UNITED STATES
NUCLEAR REGULATORY COMMISSION
WASHINGTON, D. C. 20555

SAFETY EVALUATION BY THE OFFICE OF NUCLEAR REACTOR REGULATION
RELATED TO AMENDMENT NO. 87 TO FACILITY OPERATING LICENSE NO. DPR-23
CAROLINA POWER AND LIGHT COMPANY
H. B. ROBINSON STEAM ELECTRIC PLANT, UNIT NO. 2
DOCKET NO. 50-261

Nuclear Steam Supply System (NSSS) RELAPS/MOD1.5 Noding Diagram.
 FIGURE A-1

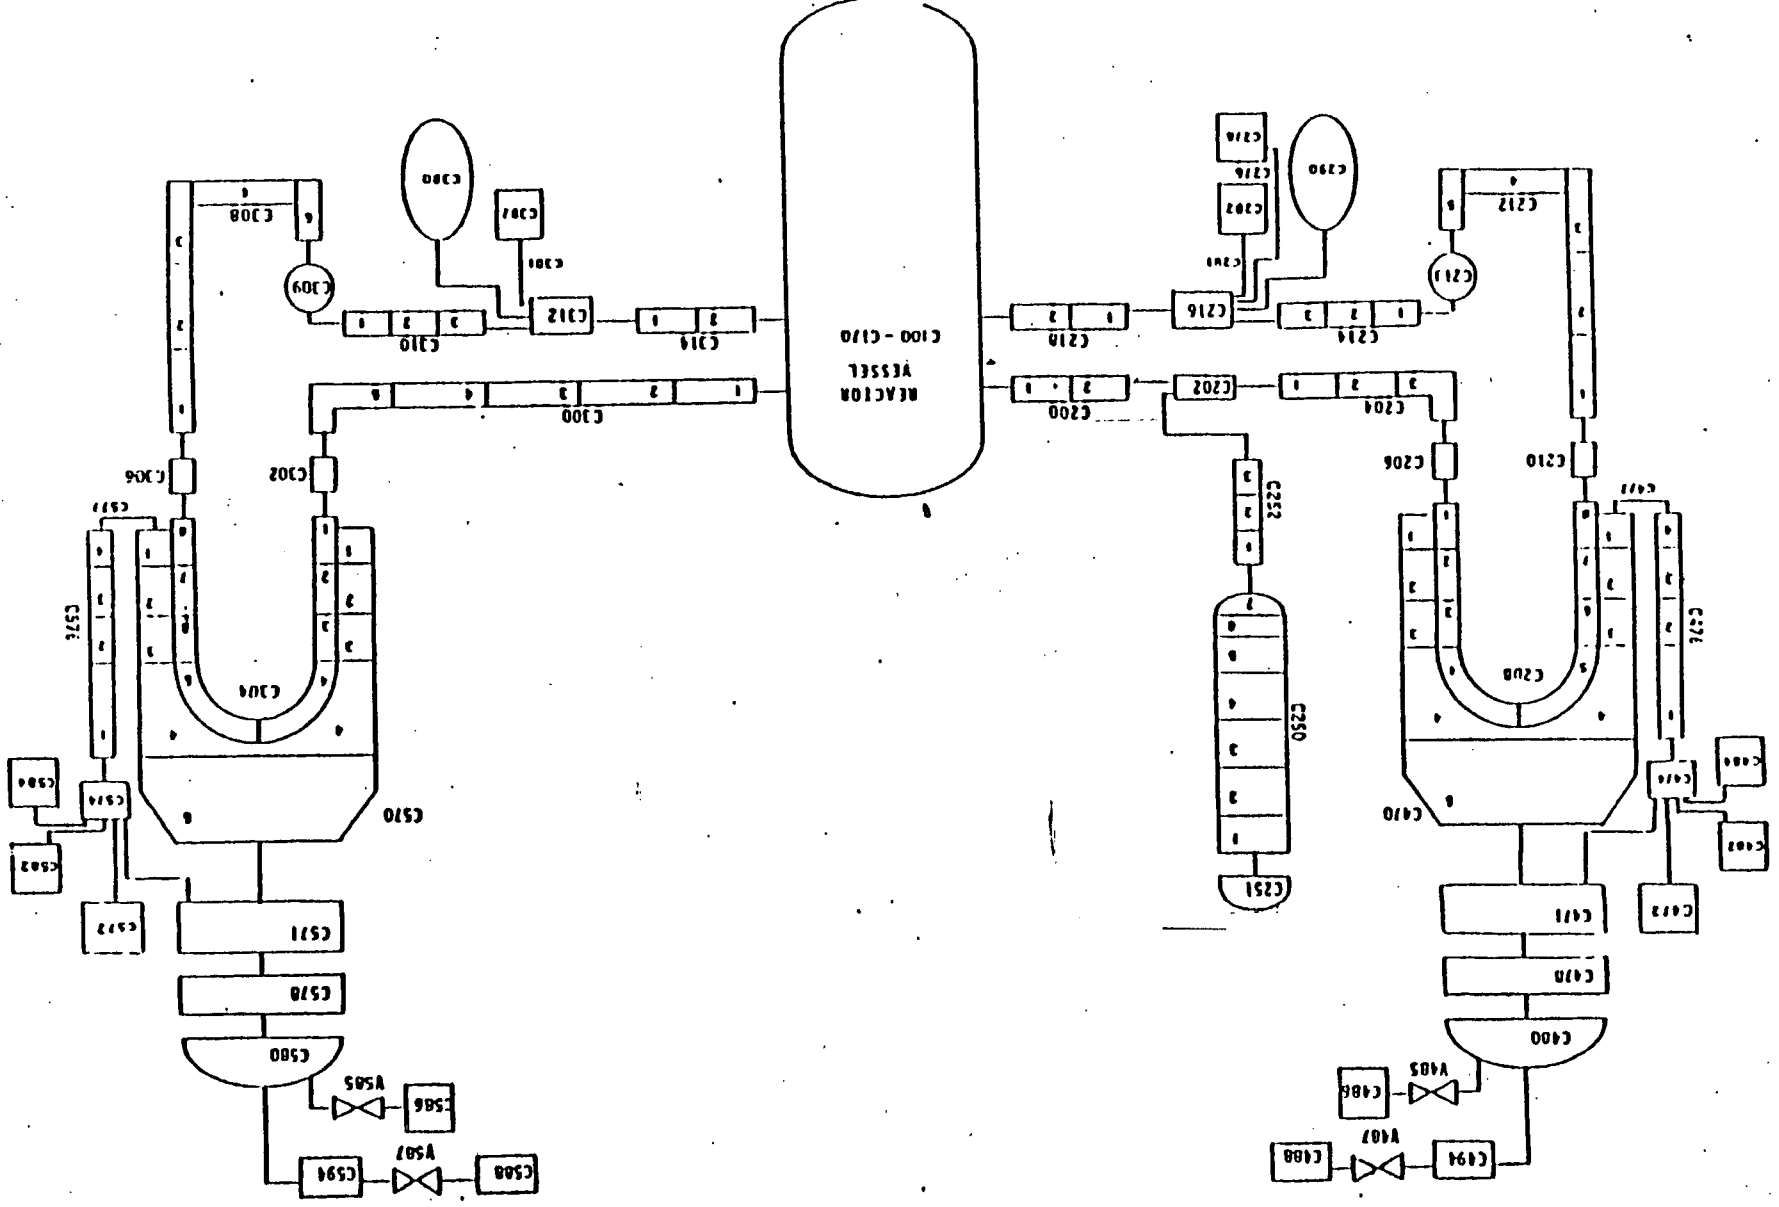
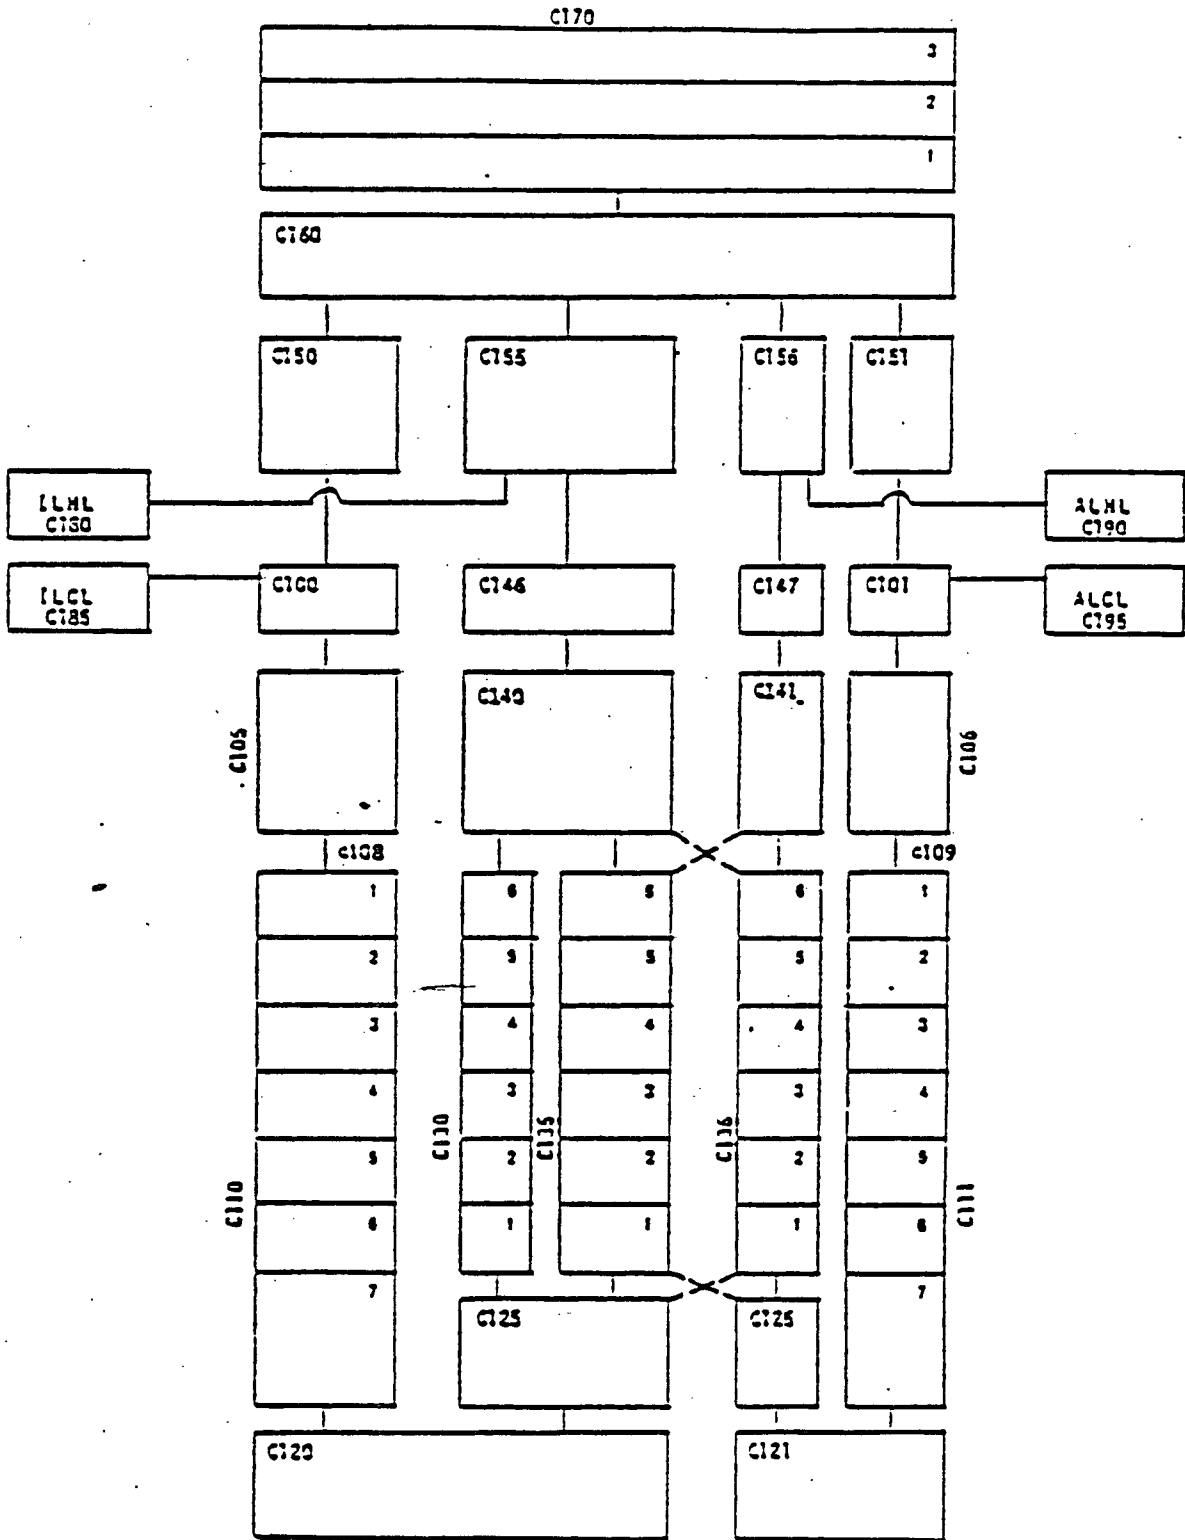
The model nodalization used for the H. B. Robinson SLB calculations is shown in Figs. A-1 and A-2. This nodalization represents the major components and flow paths of the H. B. Robinson 3-loop nuclear steam supply system.

The model consists of two loops. The intact loop is a lumped representation of two loops containing the unaffected steam generators. The pressurizer is connected to the unaffected loop. The affected loop contains the steam generator with the faulted steam line.

H.B.ROBINSON CYCLE 10 RELOAD
STEAM LINE BREAK ANALYSIS
BREAK DOWNSTREAM OF FLOW RESTRICTORS
FIGURE A-8

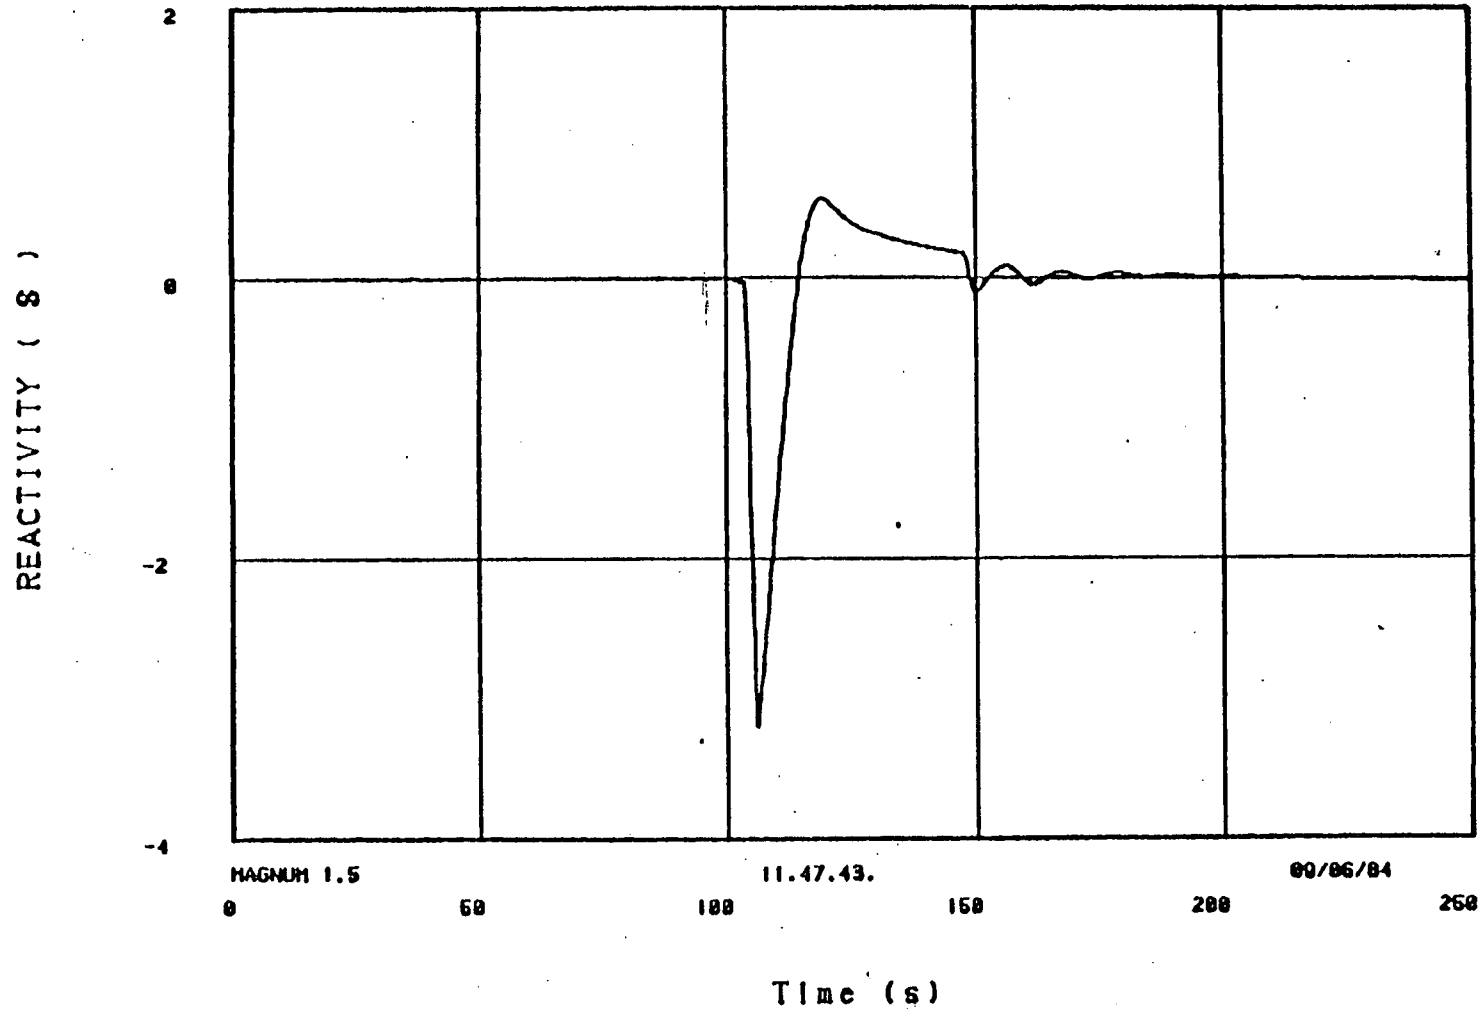
The reactivity for the limiting case is shown in Figure A-8 and A-9. The initial reactivity begins at zero. \$3.61 of negative reactivity is inserted by the control rods between 0.2 and 2.4 seconds. As the primary system is cooled, positive reactivity is inserted by the moderator and Doppler feedbacks. Criticality occurs at 14.6 seconds. At 19 seconds the reactivity peaked at \$0.58. At 46.6 seconds, boron enters the core through the emergency core cooling system (ECCS).

Time (s)
H.B.ROBINSON CYCLE 10 RELOAD
STEAM LINE BREAK ANALYSIS
BREAK DOWNSTREAM OF FLOW RESTRICTORS
FIGURE A-10

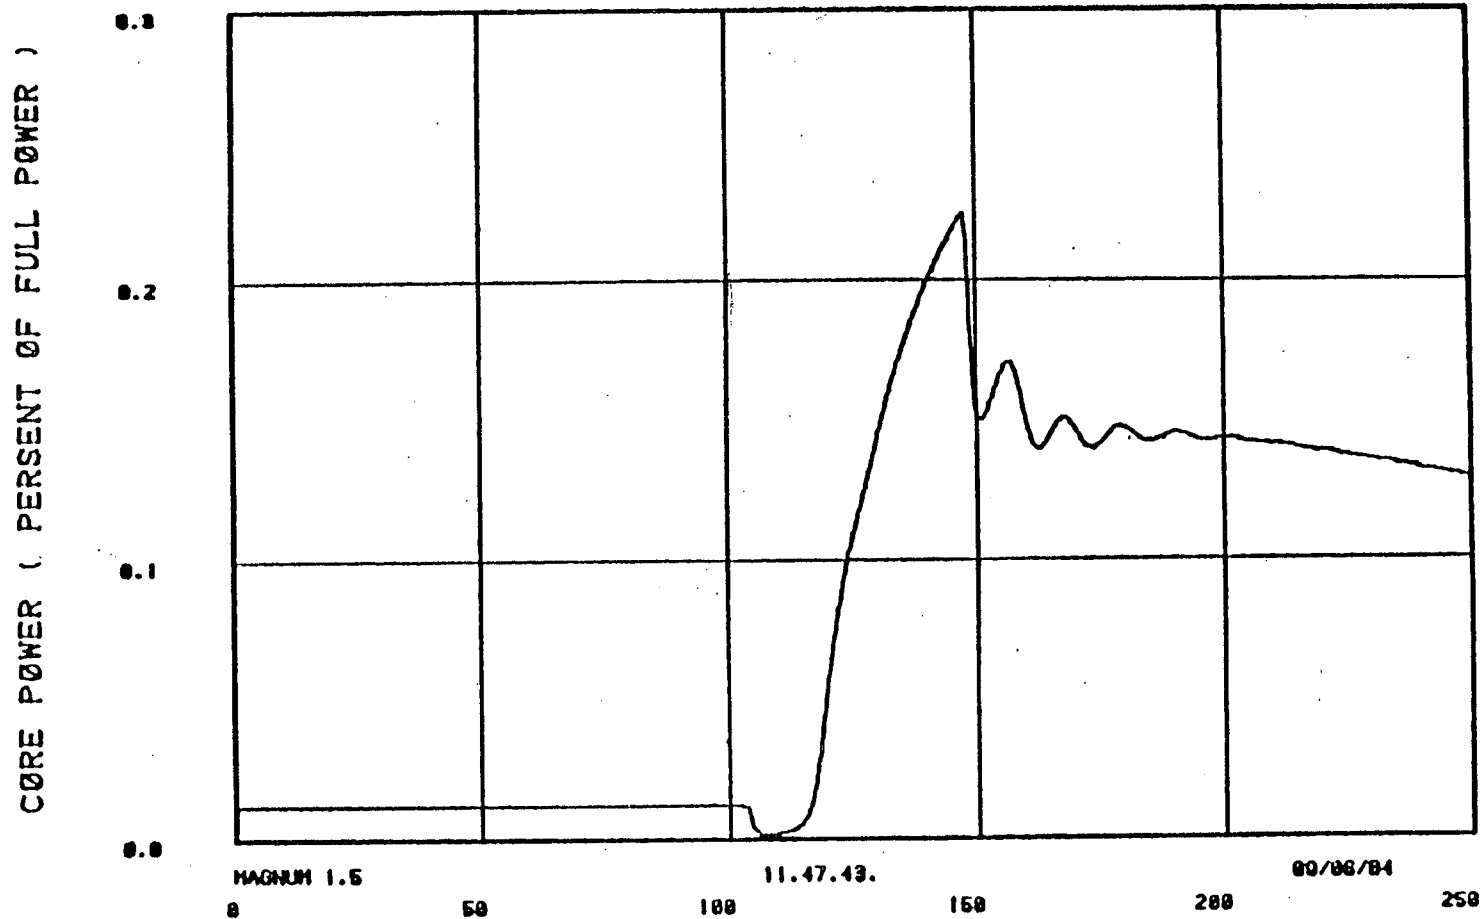
The reactor power response is shown in Figure A-10. The power peaked at a value of 22.4% of rated power (2300 MWt) at 47 seconds. Competing effects between the boron and Doppler reactivities led to some oscillatory power response.

FIGURE A-11

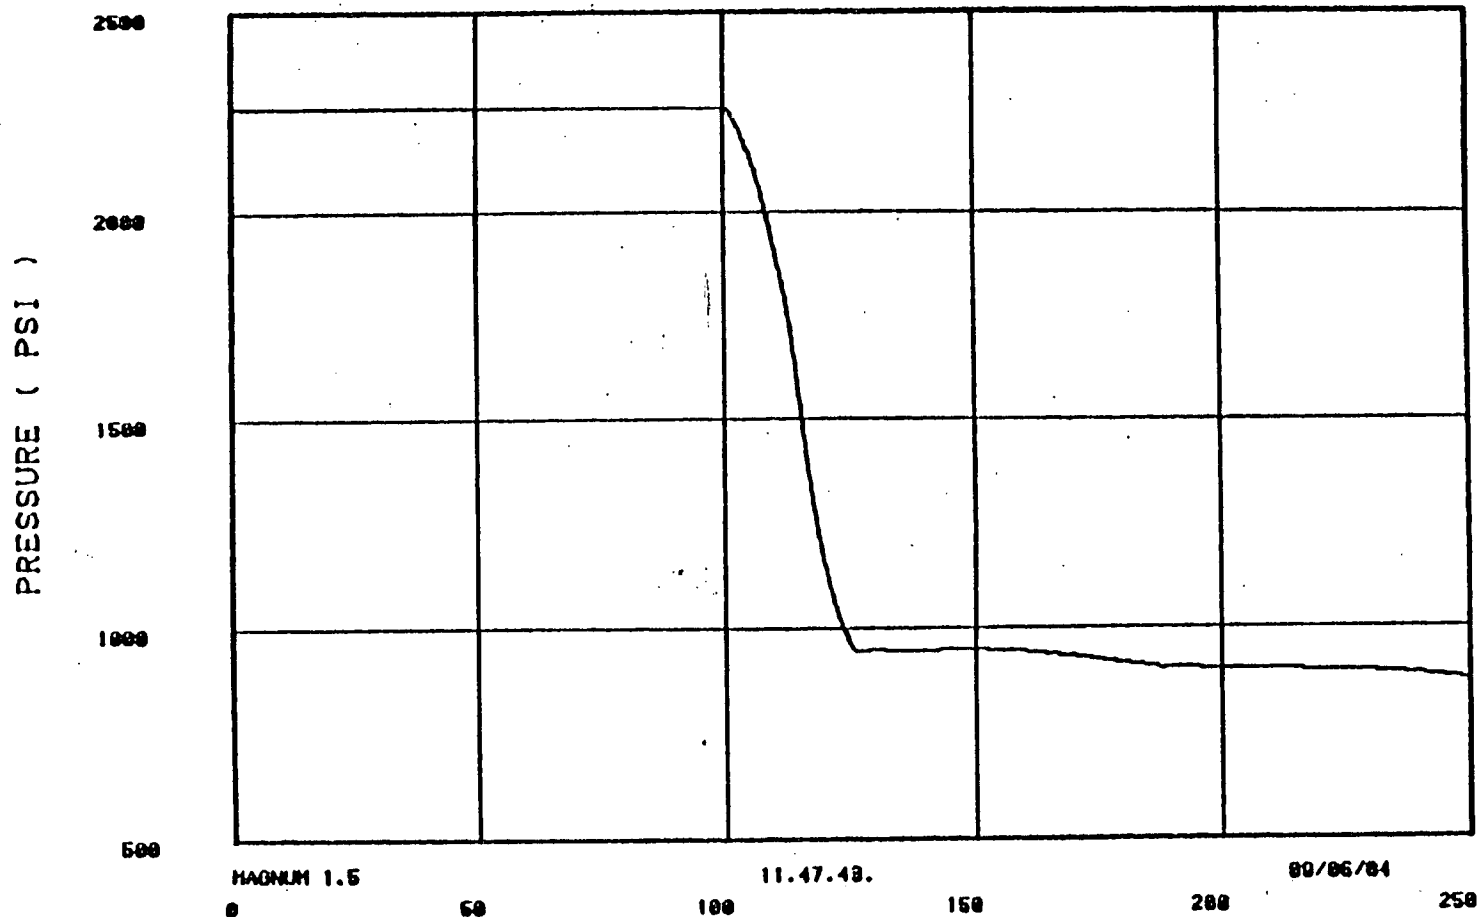
Heat removal from the primary system led to a rapid decrease in primary system pressure (see Figure A-11). The depressurization rate is significantly reduced as the reactor vessel voids within the upper head. The pressurizer is depleted of liquid inventory at the same time as the depressurization rate decreased (see Figure A-12).

Time (s)
H.B.ROBINSON CYCLE 10 RELOAD
STEAM LINE BREAK ANALYSIS
BREAK DOWNSTREAM OF FLOW RESTRICTORS
FIGURE A-13

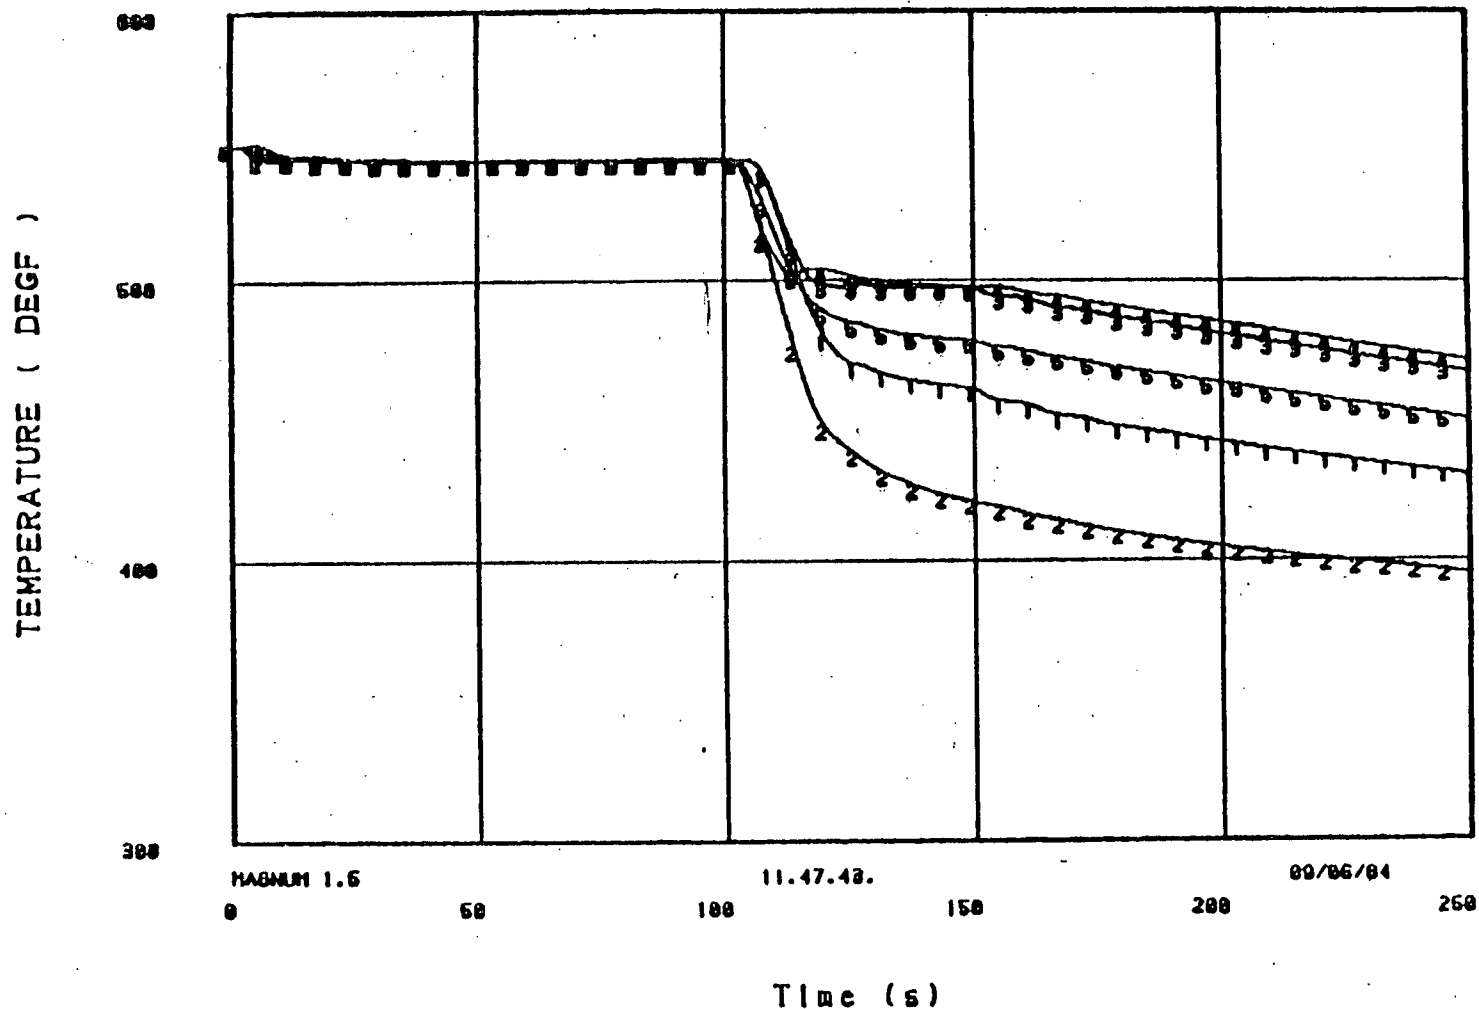
The hot leg and cold leg coolant temperature for both the affected and intact loops, along with the average core coolant temperature, are shown in Figure A-13. As noted by the decreasing coolant temperatures, the energy removed by the steam generators exceed
